10/542,642

Office Action Summary	Application No. 10/542,642	Applicant(s) KIM ET AL.	
	Examiner PATRICIA DAVIS	Art Unit 4111

DETAILED ACTION

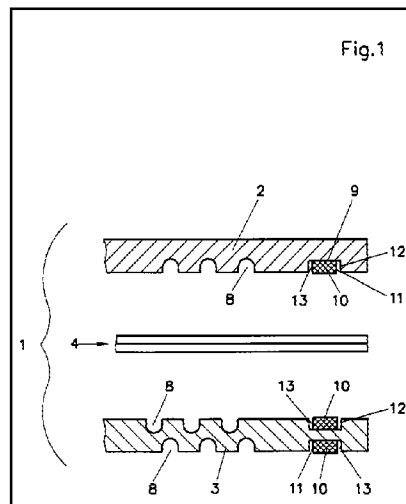
1. Regarding claim 1 and 9, Schilling teaches a sealing structure for polymer electrolyte fuel cell comprising: a bipolar plate (2 and 3) with sealing groove (9) to be filled with a rubber dispenser (using an injection process); (see col. 3, lines 48-50) and a gasket (sealing element 10) interposed between said bipolar plate and a membrane electrode assembly (MEA 4; figure 1).

Regarding claim 9, Schilling also teaches a polymer electrolyte fuel cell comprising said sealing structure (col. 3, lines 39-60).

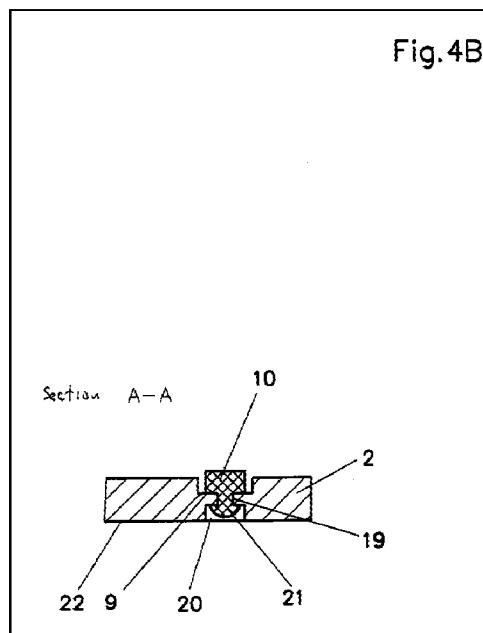
2. Regarding claim 5, as shown in figure 4B, Schilling teaches a sealing structure for polymer electrolyte fuel cell (sealing system; fig. 4B), wherein said anchor (10
- 5 sealing element) is formed vertically to a route direction of said sealing groove (9) in the periphery of said sealing groove (see col. 4, lines 23-35; fig. 4B).

1. Regarding claim 2, Schilling teaches a sealing structure comprising an anchor (10 sealing element) in contact with said sealing groove (9) (col. 4, lines 23-35; figure 4B). Schilling does not specifically teach that the anchor width is greater than the
15 sealing groove.

3. Regarding claim 4, Schilling does not specifically teach a sealing structure for a polymer electrolyte fuel cell, wherein said sealing groove (9) and said anchor (10 sealing element) have the same depth (figure 4B).

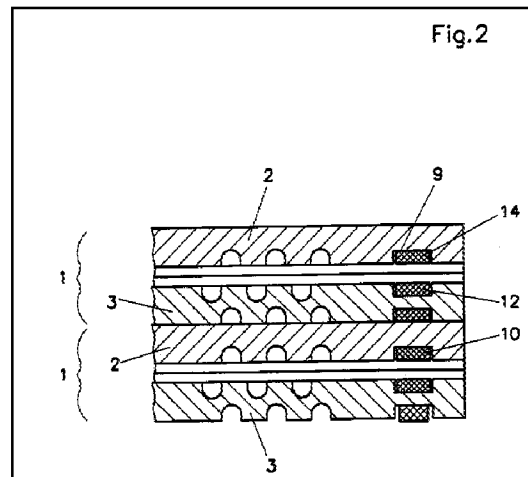
10 4. Regarding claim 6, Schilling teaches the sealing structure for polymer electrolyte fuel cell, wherein said anchors (10 sealing elements) on each of said plate (1 single cell) are located in the front of said membrane electrode assembly (see col. 3, line 61- col. 4, line 1; fig. 2).

Schilling does not teach the sealing structures being placed at the rear of the
15 membrane electrode assembly, with the front and rear plates located symmetrically to each other.

However, the Courts have held that the mere duplication of parts, without any new or unexpected results, is within the ambit of one of ordinary skill in the art. See *In re Harza*, 124 USPQ 378 (CCPA 1960) (see MPEP § 2144.04).

20 By adding more anchors around the periphery of the sealing sites it would be able to absorb more pressure effectively by distributing the pressure uniformly.

Therefore, in this case it would be obvious to one with ordinary skill in the art to add

anchors to both the rear and front of the membrane electrode assembly and locate them symmetrically to each other (see figure 2).
